Net Zero Grid Pathways 1

Major Capex Project (Staged) updated

Attachment I: Summary of Commerce Commission RFIs and responses

Date: 25 September 2023

Figure 7: Factual vs. counterfactual generation mean South Island hydro spill

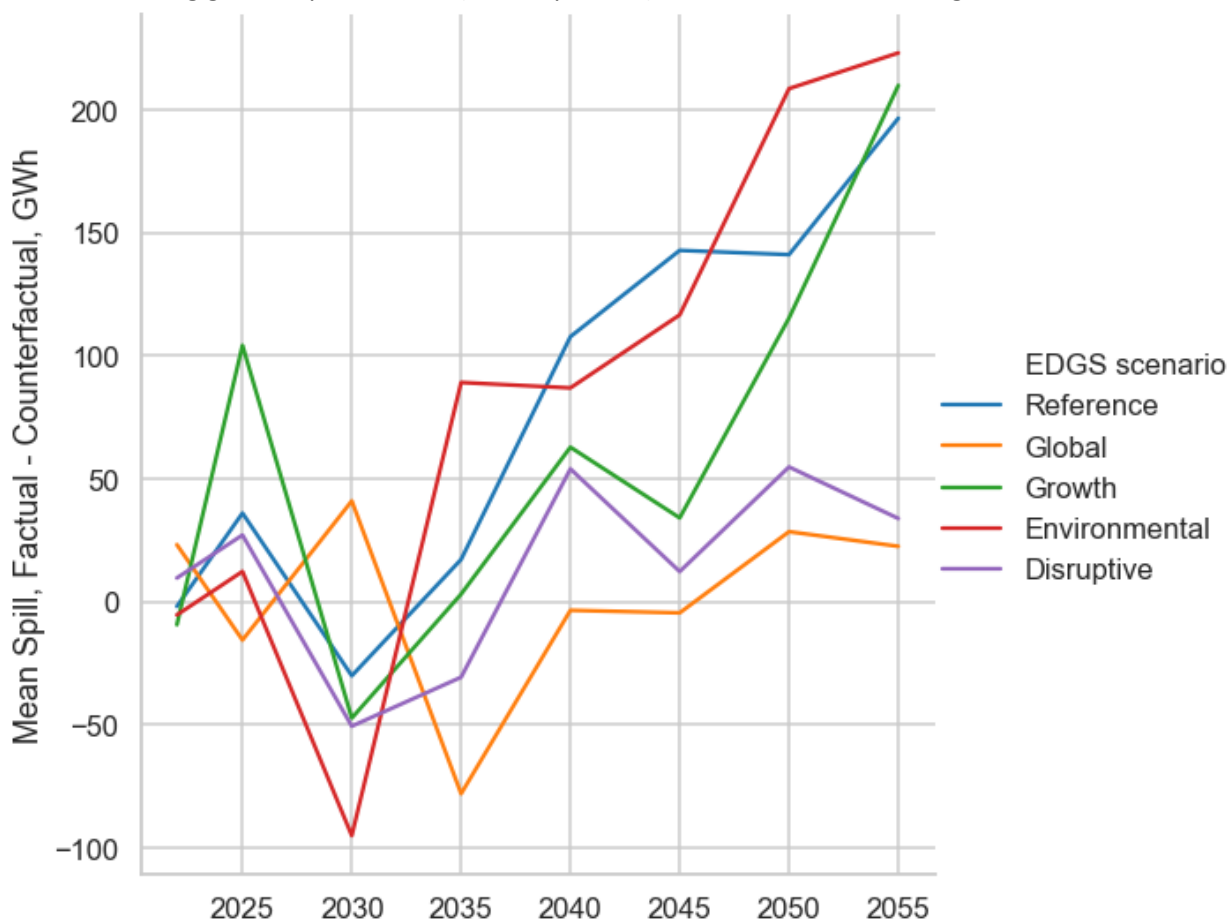
- b. *Would there be any material market costs if Tiwai exits and Transpower does not upgrade the HVDC? I.e. did the SDDP results show any spill costs? Spill costs are not shown in the spreadsheet, but we understand they may be included in the thermal operating costs. Our initial assessment is that any spill costs would be very low because the thermal operating benefits are low until 2035. Please note that the upgrade can only save up to the increased capacity (120 MW) of spill rather than all the generation that is constrained.*

Figure 7 shows differences in South Island hydro spill (for the main catchments only) between the factual and counterfactual. The factual and counterfactual are as defined above. There are relatively small differences between factual and counterfactual spills. In 2030, spill is lower in the factual for all scenarios and this does correspond to higher factual generation for this year. For some scenarios spill differences increase post 2040, this is likely related to the factual for these scenarios having greater quantities of (less responsive) installed wind and solar generation.

Figure 1: Main South Island catchments total mean spill for the disruptive and global scenarios

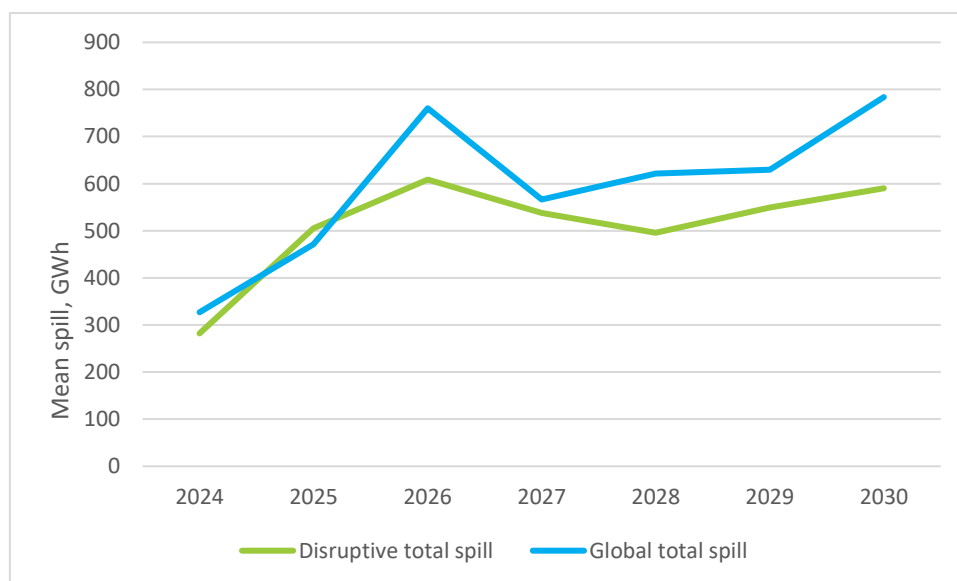
- b. Please provide us the expected annual spill in MWh if Tiwai leaves in 2024 until the new STATCOM is installed, assuming P50 HVDC transfer.*

We attach, in the spreadsheet 'rfi08_spill_summary.xlsx', annual spill for the disruptive and global scenarios for 2024 through to 2030 for the factual, as defined above. These results are derived from yearly dispatch modelling 'snapshots' using an hourly resolution.

Mean annual spill, for the disruptive and global scenarios, summed over the Clutha, Waitaki and Manapouri catchments is shown in Figure 1.

Figure 2: Generation, battery flows, HVDC flows and demand for the HAY-BPE region.

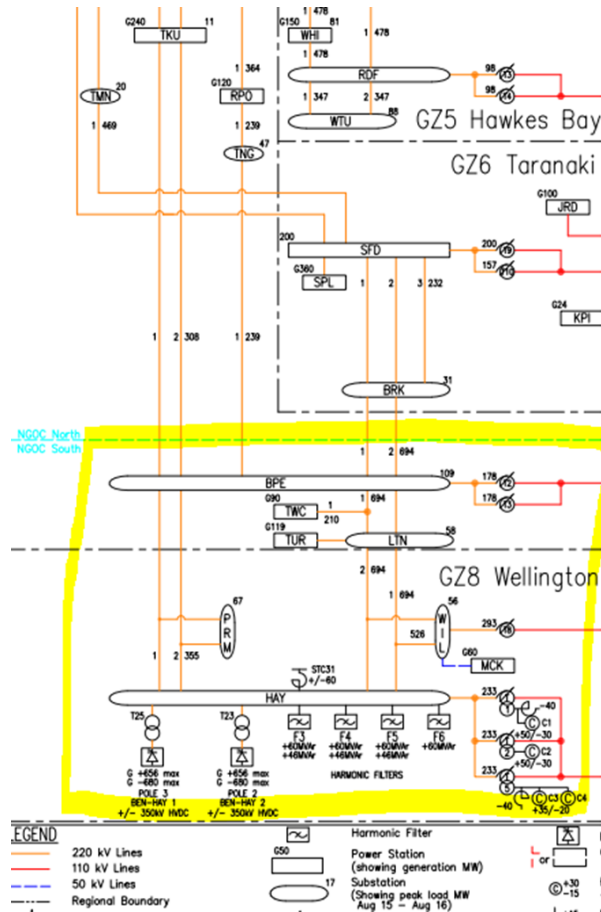
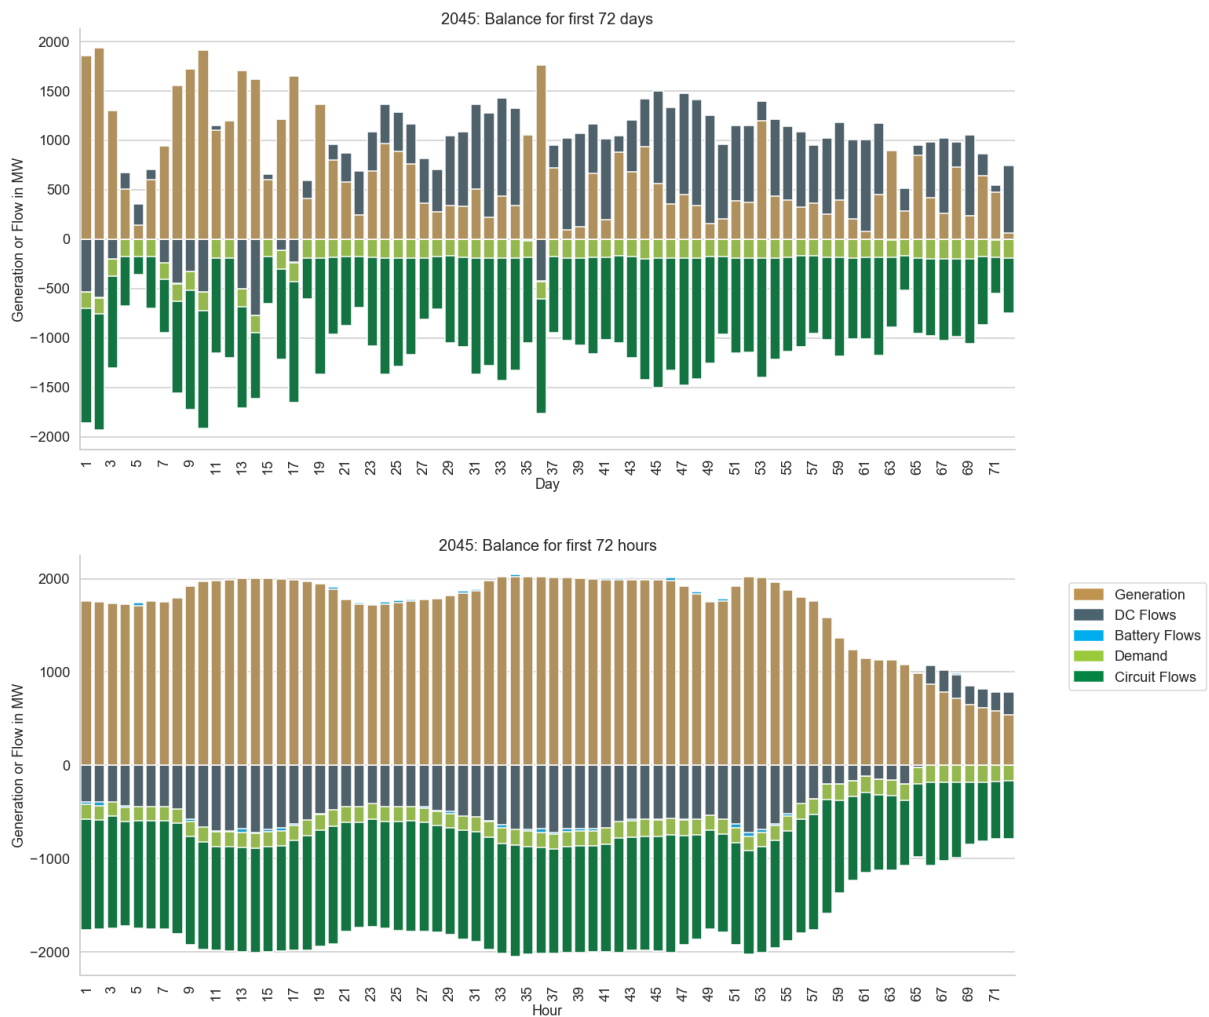
The generation expansion plan (a spreadsheet that Transpower provided) shows that more than 1.9 GW of additional generation is proposed for the Lower North Island (i.e. Region 2). Stage 1 investments are expected to increase the north transmission capacity from 750 MW to 1350 MW or a net increase of about 600 MW. If the impact of the new BPE line is not included in the investment test, then please reconcile how 1.9 GW of new generation will be exported out of BPE to the northern load centres when the net increase in capacity is 600 MW.

We confirm that generation and circuit flows reconcile in the lower North Island. To demonstrate this, we have considered the Growth scenario, with the HVDC fourth cable installed in 2027 and with the proposal's preferred AC grid transmission investments. These transmission investments do not consider a new line. We have focussed on the 220 kV grid bounded by Haywards and Bunnythorpe ("the HAY-BPE region"), as shown in Figure 1, and use hourly modelling results for 2045.

We have plotted these parameters for a single hydro inflow sequence and for a portion of 2045 in Figure 2. The top chart shows average daily generation and flows for the HAY-BPE region for the first 72 days of 2045. The bottom chart shows the hourly generation and flows for the first 72 hours. Generation and circuit flows reconcile and follow the formula above.

- Generation and circuit flows balance
- When the wind generation is high HVDC flows are either low Northwards or in some cases Southwards.
- Wind generation is closely correlated, the maximum combined wind generation in 2045 is 2027 MW (for our selected hydro inflow sequence).
- Maximum circuit flow for the CNI corridor in 2045 is 1455 MW (for our selected hydro inflow sequence). The CNI corridor includes the BPE-TKU, BPE-TNG and BPE-BRK circuits. This is consistent with Figure 21, in Attachment D of the application.
